REVIEWER NOTES

STATE OF VERMONT AGENCY OF TRANSPORTATION

PROPOSED IMPROVEMENT BRIDGE PROJECT TOWN OF JOHNSON COUNTY OF LAMOILLE

**FINAL PLANS
MAY 4, 2016**

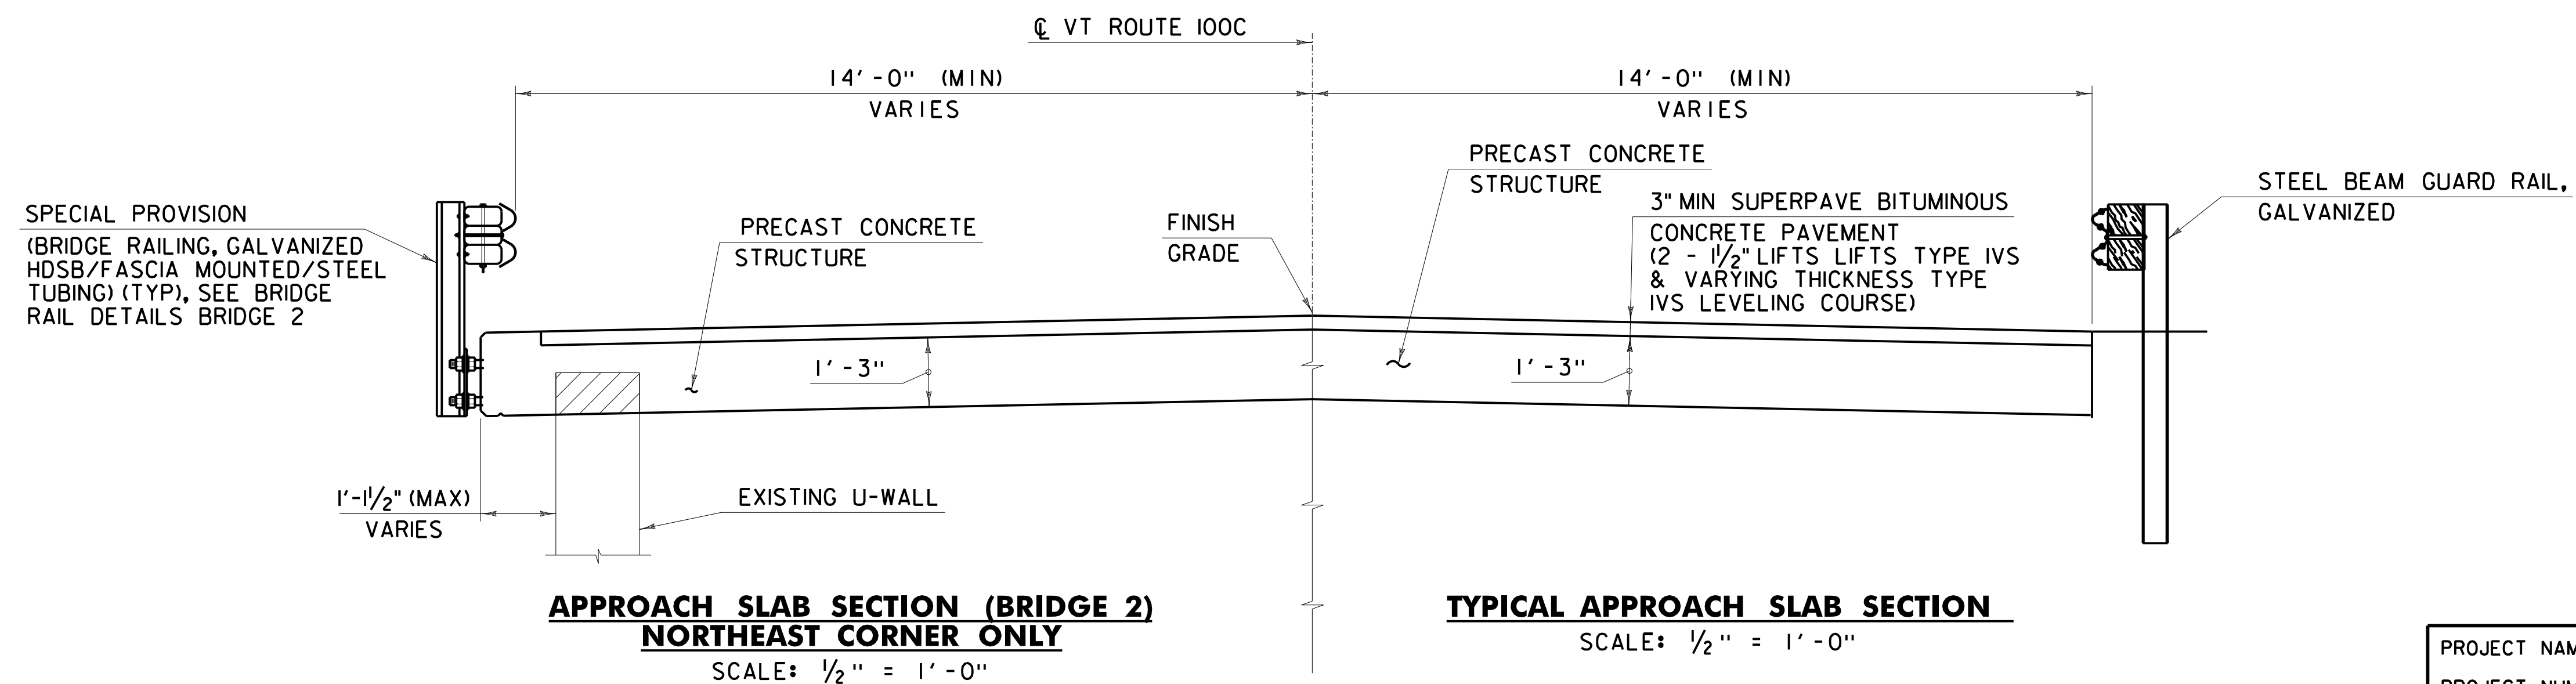
1. THE RETAINING WALL NORTHEAST OF BRIDGE 2 HAS BEEN CHANGED. THE WALL TYPE HAS NOT BEEN DETERMINED, BUT VTRANS HAS DIRECTED US TO REFER TO "SPECIAL PROVISION (RETAINING WALL)" AND PROVIDE A GENERIC CROSS SECTION. ADDITIONAL DETAILS WILL BE PROVIDED WITH A FUTURE SUBMISSION.
2. HYDRAULIC ANALYSIS OF BELL BROOK WILL BE REQUIRED. IT IS ASSUMED THAT STONE FILL, TYPE III WILL BE USED AS BACKFILL FROM TOP OF BEDROCK TO THE EXISTING GROUND ELEVATION ON THE OUTSIDE FACE OF THE REVISED RETAINING WALL NORTHEAST OF BRIDGE 2.

NOTE: WALL SHALL BE DESIGNED ASSUMING MATERIAL AT OUTSIDE FACE WILL WASH AWAY, THEREFORE DESIGN HEIGHT WILL BE FROM TOP OF FINISH GRADE ON INSIDE FACE TO TOP OF BEDROCK.
